PHAP18-00014

ITEM #2

Certificate of Appropriateness for the removal of casement windows and replacement with sash windows

WINDOW ELEVATION

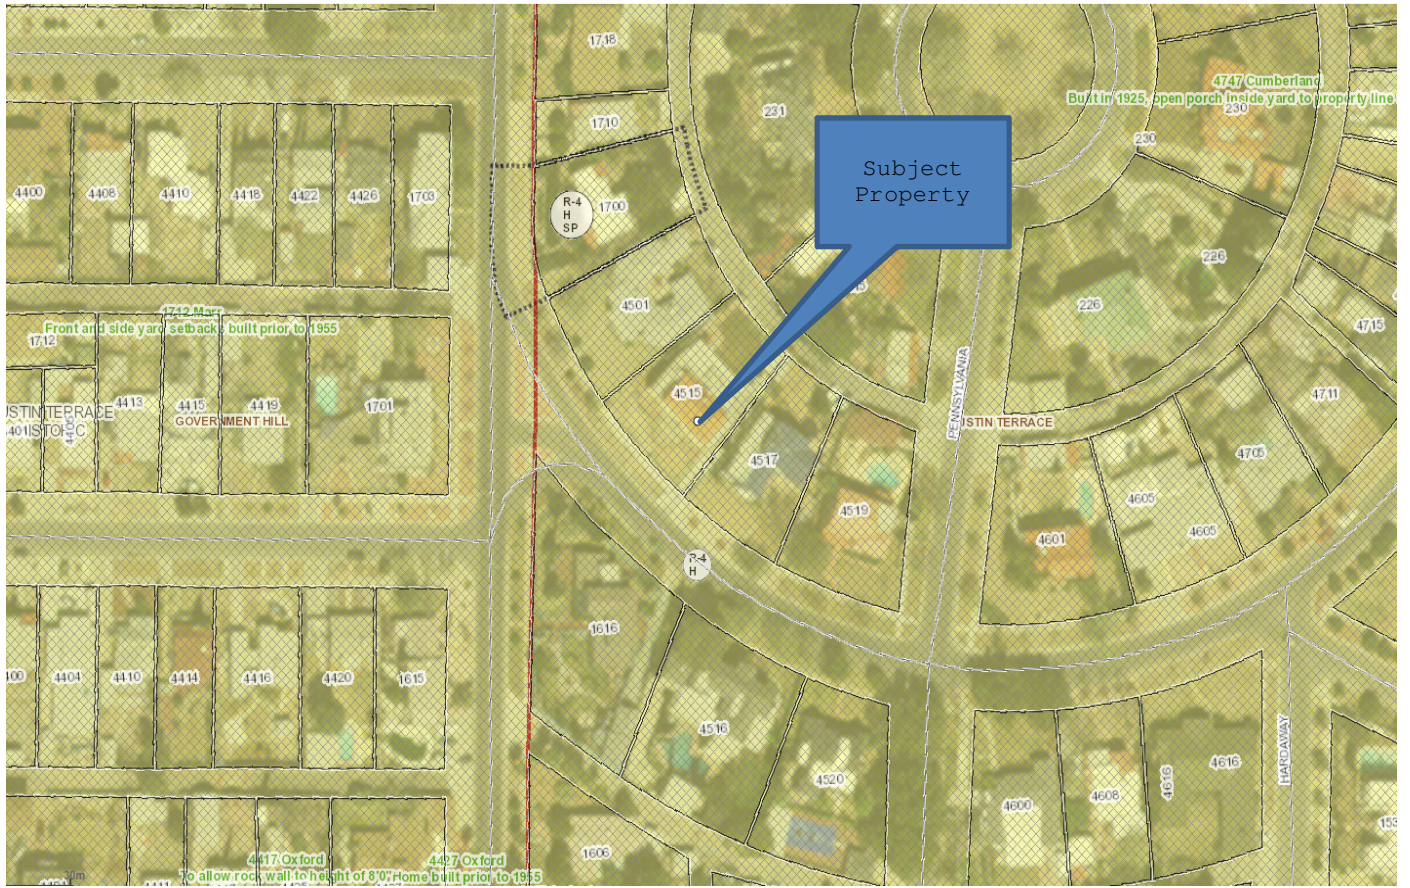
The Historic Preservation Office recommends APPROVAL WITH A MODIFICATION of the proposed scope of work based on the following recommendations:

The modification is that the windows be operable, double-leaf, multi-light casement windows with three dimensional muntins to match the existing.
